Danfoss

Parts Manual

Series 90

55cc Axial Piston Pump

Servo arm change

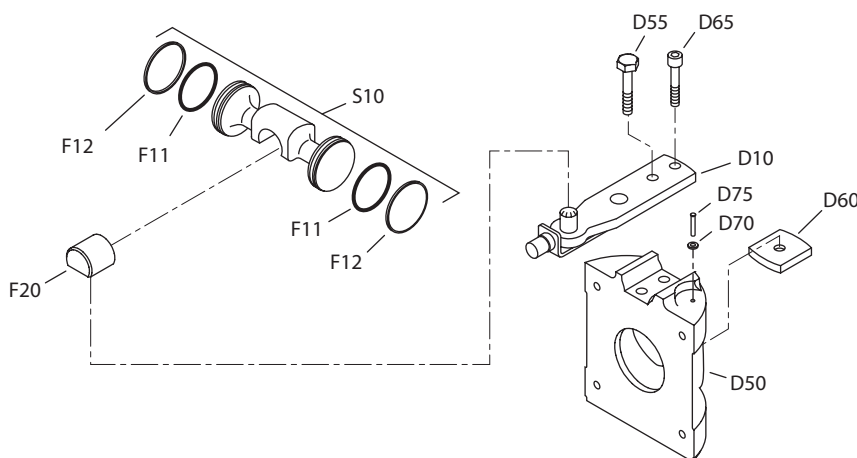
As a product improvement, Sauer-Danfoss has changed the series 90 pump servo arm and swashplate (item D10 and D50). The old style servo arm and swashplate will become obsolete. Because this change creates non-interchangeability between new and old swashplates, servo arms, and possibly servo piston (item S10) and slider block (item F20), separate servo arms and swashplates will no longer be sold as service parts.

Also, the new servo arm is actually a press fit into a groove in the new swashplate. This situation requires special tooling for assembly, therefore, pre-assembled kits will be created for 55, 75, and 100 cc pumps. The kits will work in any vintage pump.

The kit for 55 cc pumps will include all the items in the figure, except item S10

The kit for 75 cc pumps will include all item in the figure.

The kit for 100 cc pumps will include all items in the figure, except items S10 and F20.

Change goes into effect with s/n 88-14-xxxxx on 55 cc pumps and with s/n 88-16-xxxxx for 75 cc and 100 cc pumps.

Change to fixed clearance slipper hold down

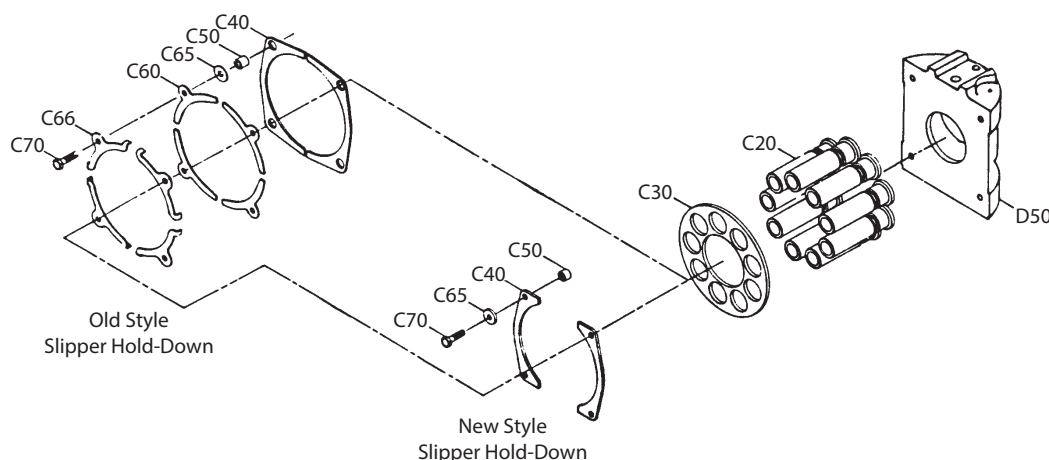
As a product improvement, Sauer-Danfoss has simplified the design of the series 90 pump slipper hold down mechanism. The hold down changes from spring loaded with a fixed maximum clearance design.

The leaf spring (item C60) and spring aligner (item C66) will be eliminated and will not be available as service parts.

The spacer (item C50), bearing (item C40), and washer (item C65) will change and the old part numbers will not be available as service parts.

Service Bulletin: SB-1988-024

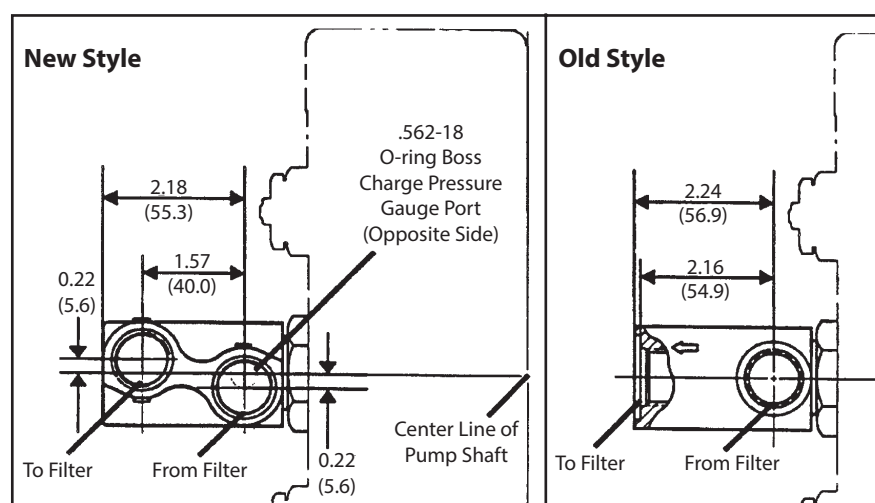
Subject Remote pressure filtration adapter change

Description The configuration of the remote pressure filtration adapter, available as an option on Sauer-Danfoss series 90 variable pumps (55, 75, and 100 cc) is changing. This improved design adapter incorporates a charge pressure test port. In addition, the remote filter connections have been relocated to improve the customer interface and the routing for filter plumbing on most applications. Port sizes did not change. (A version of the improved design adapter is already being used on Series 90 42 cc variable pumps.)

This change does not affect the pump end cap, and either design filtration adapter can be used on any vintage pump. Only the new style adapter will be available as service parts or on new production pumps.

Charge pump design change

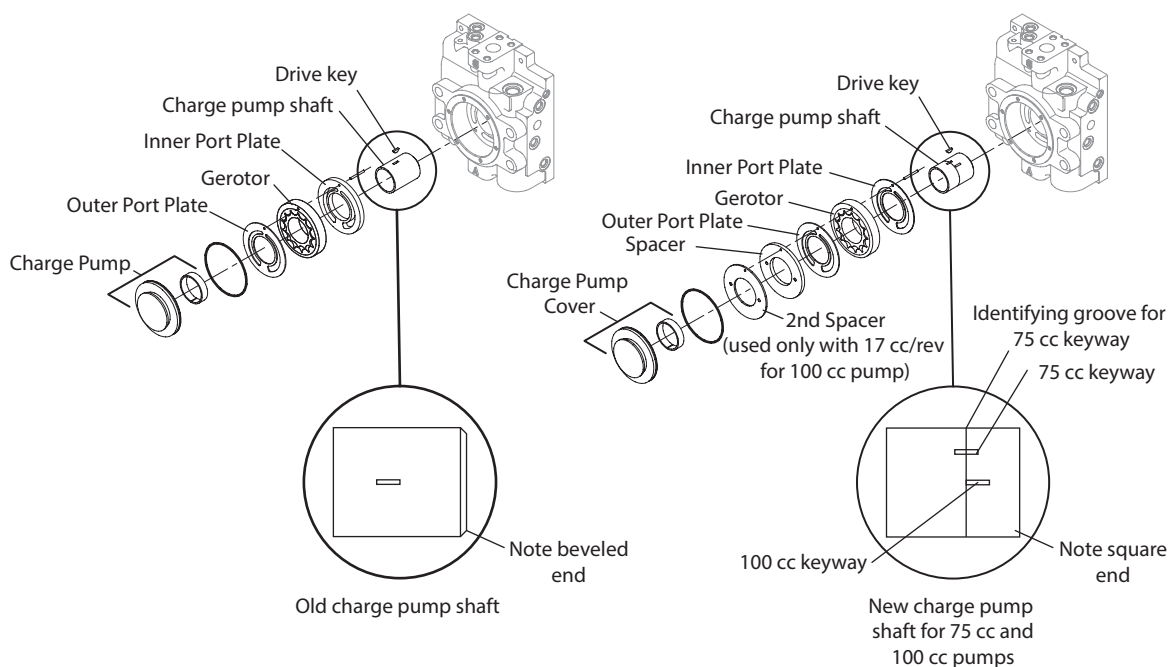
Models affected	All 94-2xxx (55 cc), 95-2xxx (75 cc), and 96-2xxx (100 cc) pumps
Serial numbers	A-89-17-xxxxx for all pumps manufactured in Ames, Iowa. N-89-07-xxxxx for al 95-2xxx (75 cc) pumps manufacture in Neumunster, West Germany. N-88-48-xxxxx for all 96-2xxx (100 cc) pumps manufacture in Neumunster, West Germany.
Part numbers affected	Proper part number versus pump serial number information can be found in the series 90 Parts Manuals. The thicker inside port plates (thicker than 0.050 in (1.27 mm) will be obsoleted and no longer available as service parts. If these parts require replacement, use the 0.050 in. 1.27 mm) port plate and appropriate spacer(s) as service parts. On 100 cc pumps only, the new charge pump shaft must be used if the new style spacer is used, On 55 and 75 cc pumps, the charge pump shaft clearance pocket in the end cap changed from a beveled to a straight corner to correspond with the change in the charge pump shaft. Old style charge pump shafts will remain available as service parts and must be used in the 55 and 75 cc beveled pocket end caps. Old style (beveled pocket) end caps will be obsoleted and no longer available as service parts. If an old style end cap needs replacement, new style end caps can be used with any vintage charge pump hardware and charge pump shaft.

Parts disposition	■ Non-interchangeable - must use correct charge pump shaft per serial number of pump

Change takes place at serial number A-89-17-xxxxx.

End cap and housing change

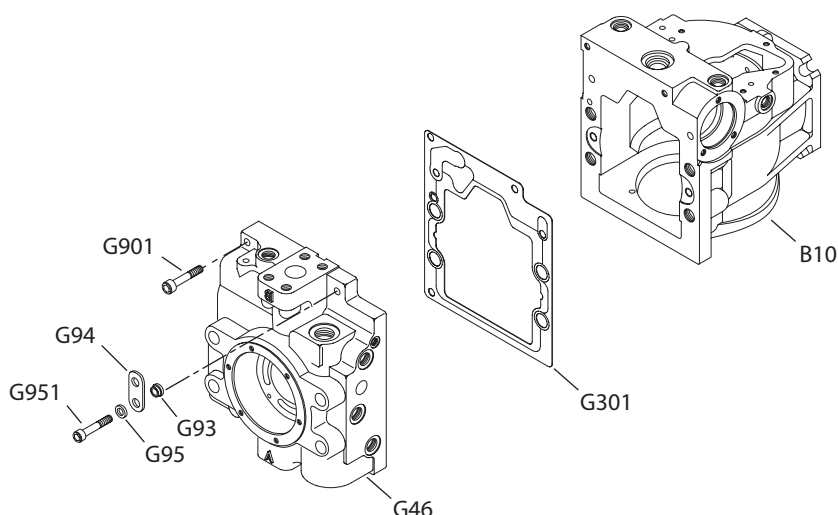
Change takes place at serial number A-89-47-xxxxx.

Service Bulletin: SB-1992-011

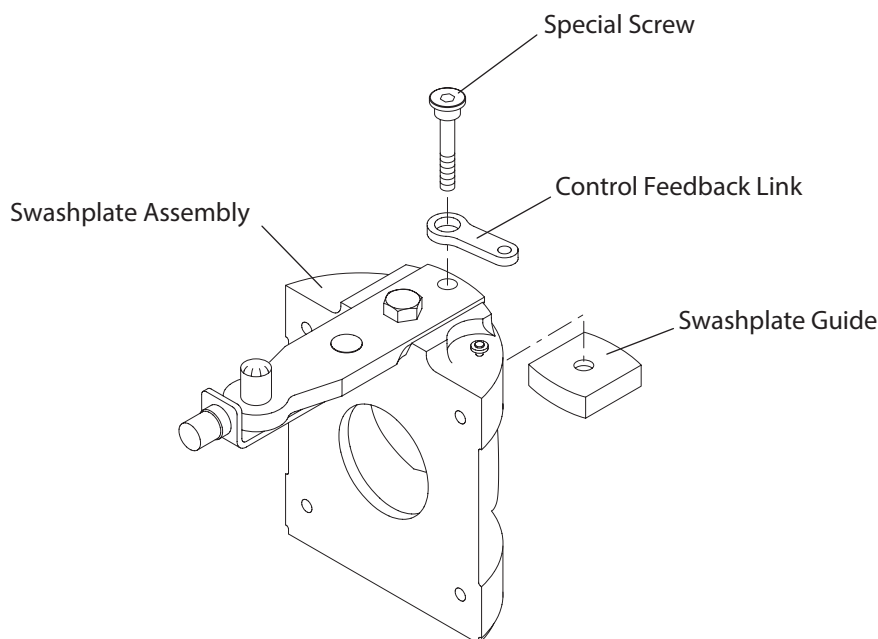
Products affected Series 90 - 055, 075, and 100 frame size pumps

Description Effective in September of 1992, the feedback link in series 90 pumps will be mechanically retained to the swashplate. In the past, the link slipped over a specially ground socket head screw and could fall off the screw during assembly. The screw has changed to include a head to retain the link. The feedback link does not change.

Swashplate cage locator

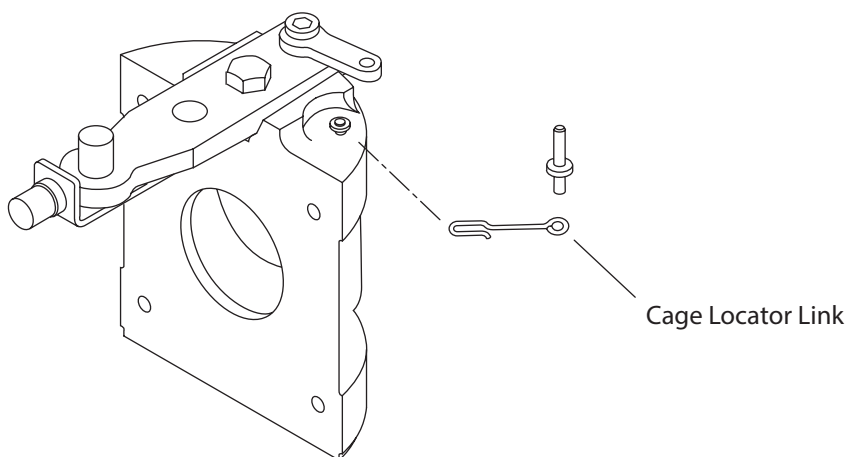
As a product improvement, Sauer-Danfoss has made a design change to the cage locator link used on the 55 thru 100 cc variable pumps.

The new link is made from square wire. In the past, the link was made from round wire. This is an interchangeable change.

Side cover washer elimination

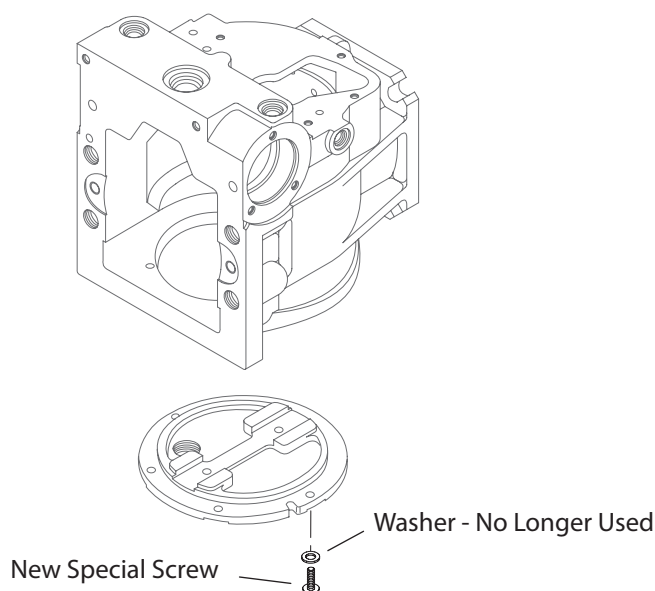
Change took place during the 2nd and 3rd quarter of 1994

Integral filtration manifold

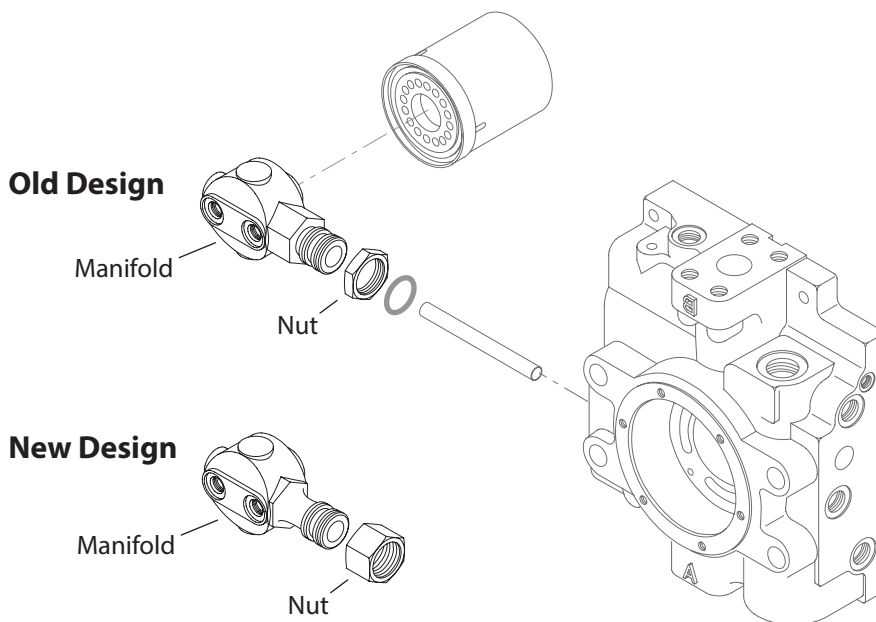
Change occurred at serial number 95-18-xxxxx

Service Bulletin: SB-1998-018

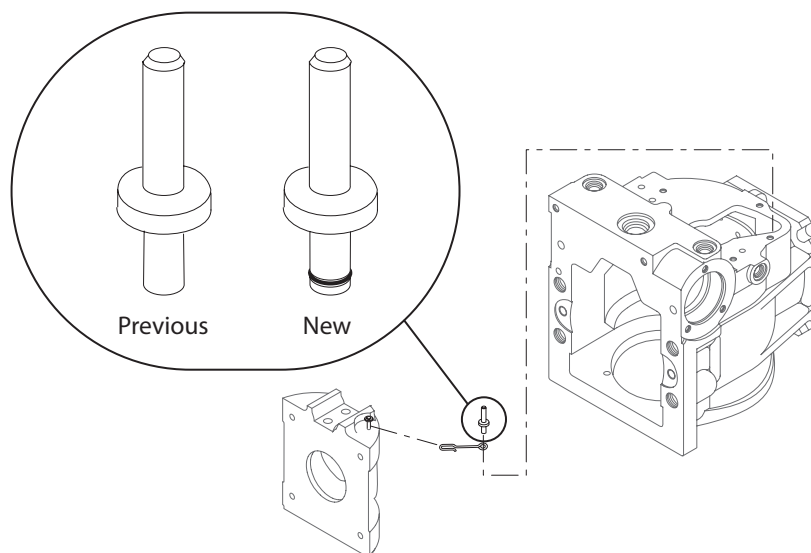
Subject Swashplate bearing cage locator pin

Description Sauer-Danfoss has modified the design of the swashplate bearing cage locator pin used in the series 90 55, 75, and 100 cc variable displacement pumps.

To aid in identifying this change, Sauer-Danfoss has released a new part number for the updated pin design. The new pin is completely interchangeable with the previous pin part number. The previous pin has been obsoleted.

Serial numbers This change became effective at serial number 98-24-xxxxx

Charge pump shaft part number change

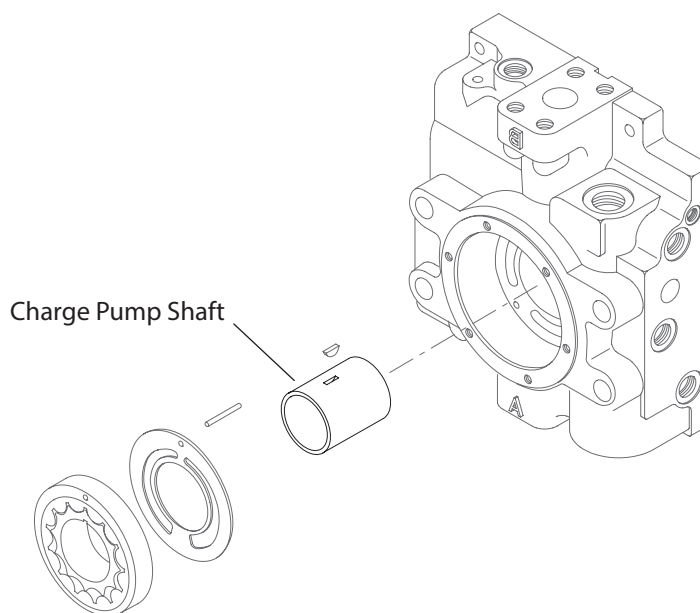
As a product improvement, Sauer-Danfoss has modified the design of the charge pump shaft used in series 90 55, 75 and 100 cc pumps. This change affects all charge pump sizes (11, 14, 17, 20, 26, and 31 cc) available in the series 90 displacement range.

The design modification includes a surface finish change to the charge pump shaft which improves the wear characteristics between the charge pump shaft and the journal bearings in the charge pump cover and end cap.

To assist in identifying this change, Sauer-Danfoss has released new charge pump shaft part numbers. The new shafts are completely interchangeable with the previous shafts. The new shaft has replaced the previous shaft in new pump assemblies and charge pump service kits. The previous shafts have been obsoleted and are no longer available as a service part. The chart on the next page will assist you in determining the part number changes.

NOTE: Pump models 9621723 and 9622117 were released with a special charge pump option (code W - 26 cc charge pump with special shaft). With this product modification, the charge pump option code for these two models has been changed from W to the standard option (code F - 266 cc charge pump). The special shaft part number 8801176 has been obsoleted and replaced with shaft part number 8801178.

Auxiliary flange charge pump cover

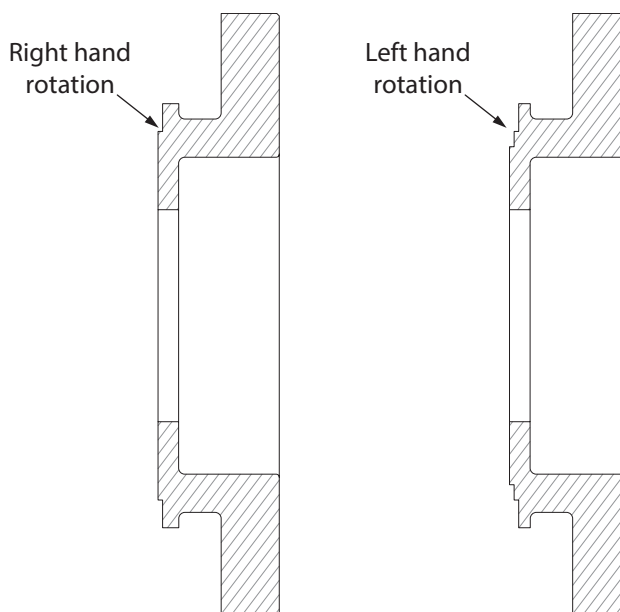
The part numbers of the charge pump covers will not change.

This change became effective at serial number A-05-17-xxxxx

Subject SAE C auxiliary mounting flange

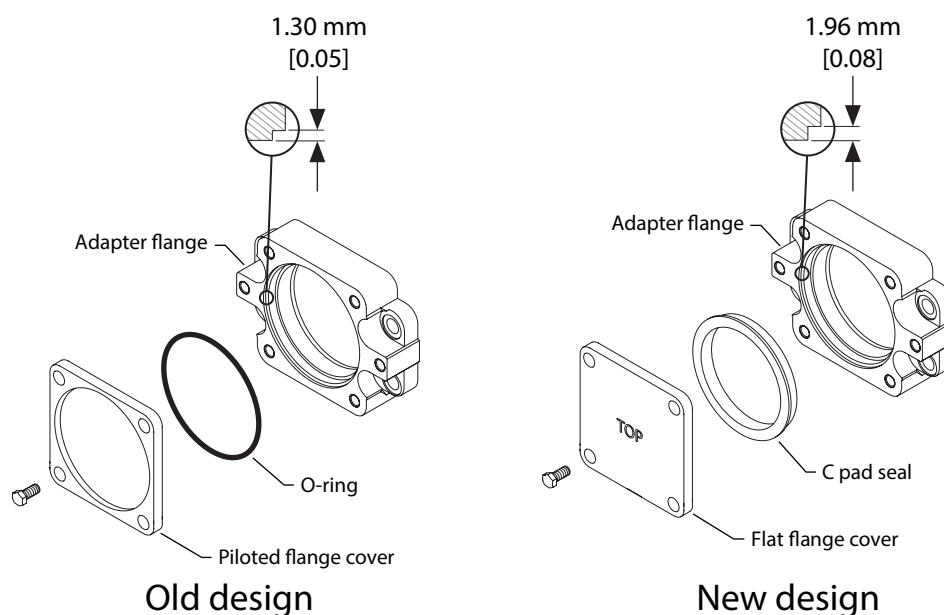
Part numbers affected Sauer-Danfoss is pleased to announce a design improvement on the SAE C auxiliary mounting flange adapter on its series 90 pumps. The frame sizes affected by this change are 55, 75, and 100cc. All manufacturing locations producing these pumps will be changed to this configuration.

The pumps will now be supplied with the donut style seal and new flat cover, instead of the small O-ring and cover plate (shown in the drawing below).

Serial numbers This change became affective at serial number; A 08-19-xxxxx and N 09-30-xxxxx.

Subject SAE B auxiliary mounting flange

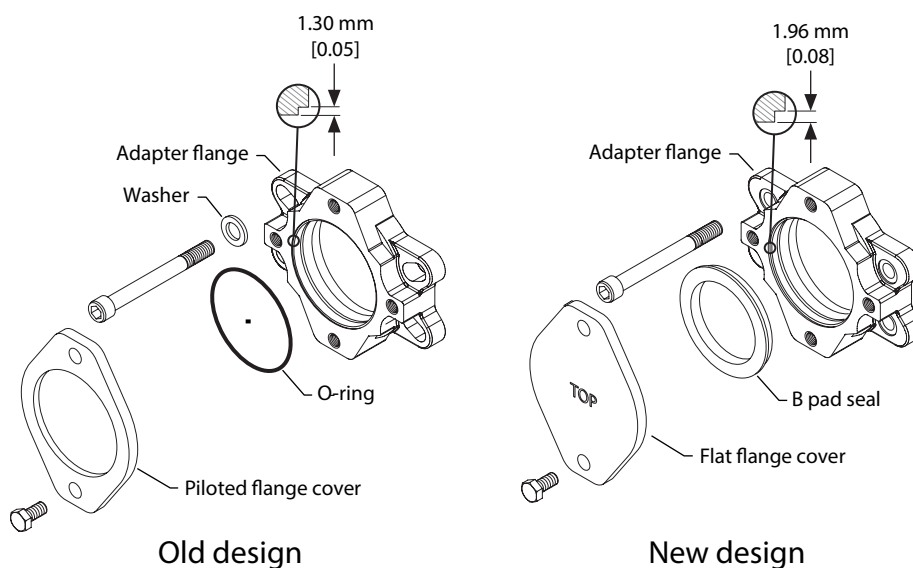
Part numbers affected Sauer-Danfoss is pleased to announce a design improvement on the SAE B auxiliary mounting flange adapter on its series 90 pumps. The frame sizes affected by this change are 55, 75, and 100cc. All manufacturing locations producing these pumps will be changed to this configuration.

The improvement comes in the form of a more robust sealing geometry with a larger cross-section O-ring. The O-ring groove in the flange will now be sized to mate with a 2.62mm [0.103] cross section O-ring rather than the old 1.78mm [0.070] cross-section O-ring. The Sauer-Danfoss part number for the new O-ring is 9004104-1540 (2.62mm [0.103] x 94.92mm [3.737]). The larger cross-section sealing geometry allows for the use of a donut style B pad seal and a new flat cover for improved assembly. This new configuration is qualified as a running cover. When installing an auxiliary pump, the donut style B pad seal must be discarded and part number 9004104-1540 O-ring used.

Also, the flanges will no longer have a slotted interface with a washer for the end cap screws. The flanges will now have round through holes for the end cap screws and will use no washers. The end cap screws do not change. This eliminates the area where water or high pressure wash chemicals can be trapped around the end cap screws. There now are specific part numbers for the flanges used on each of the three displacement size pumps; 55, 75 and 100 cc.

The pumps will now be supplied with the donut style seal and new flat cover, instead of the small O-ring and cover plate (shown in the drawing below).

Serial numbers This change became affective at serial number; A 08-19-xxxxx.
